Transmit Power Spec

Ramin Farjadrad, Aquantia

Gerrit den Besten, NXP

Transmit PSD for 2.5G/5G/10G (No Filtering)

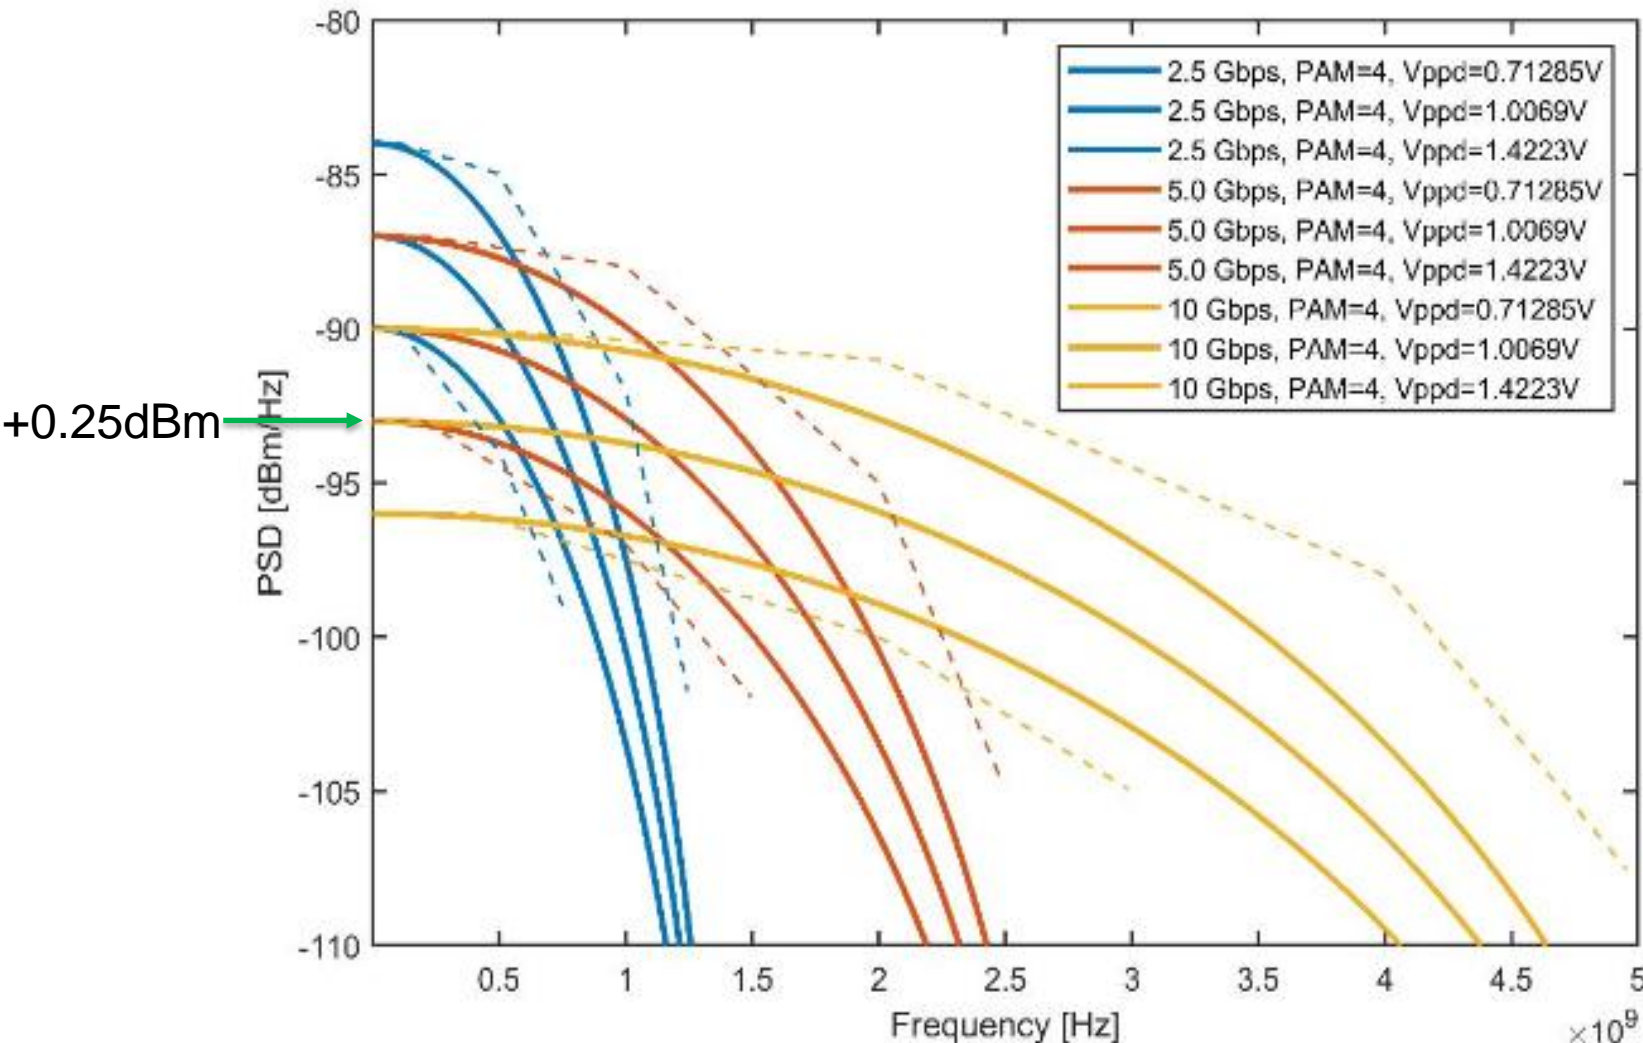
- Based on Tx Typical Output Swing of 1Vpkpk
 - Tx Power centered at ~1.5dBm
- Original Spec (Draft 1.1)
 - **0.0dBm to 3dBm**

Concerns for Tx Implementation Losses

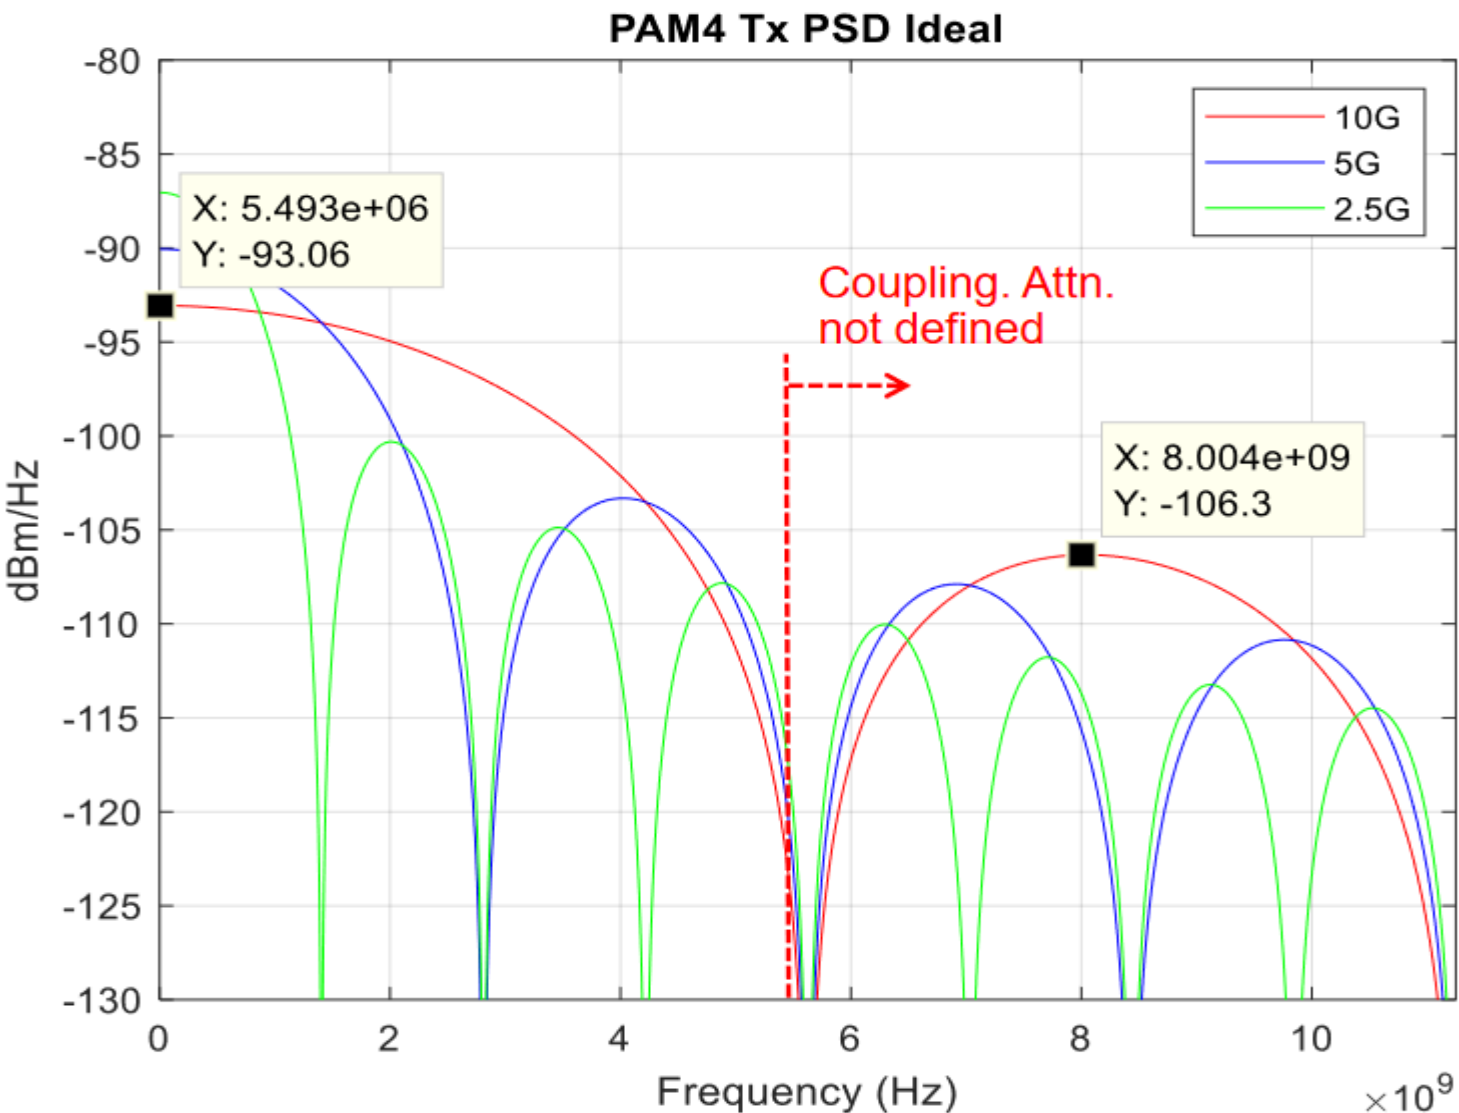
- Ideal Tx power: 1.43dBm
- Tx power with 0.5pF capacitance at MDI
 - 10G: 1.11dBm
 - 5G: 1.26dBm
 - 2.5G: 1.33dBm
- 5% Vdd variations, and 10% Rterm variations
 - -0.87dB to 0.87dB
- Impacts of additional DAC switching parasitic
 - ~ -0.3dB
- Trace and connector losses
 - At least -0.5dB, worst case -1dB
- Overall Tx power
 - 10G: -1.06dBm to 1.18dBm
 - 5G: -0.91dBm to 1.33dBm
 - 2.5G: -0.84dBm to 1.40dBm

- Analysis shows up to 2.5dB drop in Tx output power caused by different losses in the system
- Centering Tx power at 0.2dBm with tolerance +/-1.26dB covers all these losses
- But most of these loss factors are **fixed** thus can be easily tuned out. Conservatively we assume only half the loss is tuned out
 - MDI/PHY parasitic caps are fairly fixed per system, so half their effect can be tuned out by adjusting Tx amplitude → Reduce range 0.3dB
 - Rterm variations can easily be calibrated out (reference resistors) → Reduce range 0.44dB
 - Trace losses are fixed per system and can be calibrated out: → Reduce range 0.5dB

- Tx power range due to different factors can be easily reduced by at least: $0.3+0.44+0.5= 1.24\text{dB}$ (+/-0.62dB)
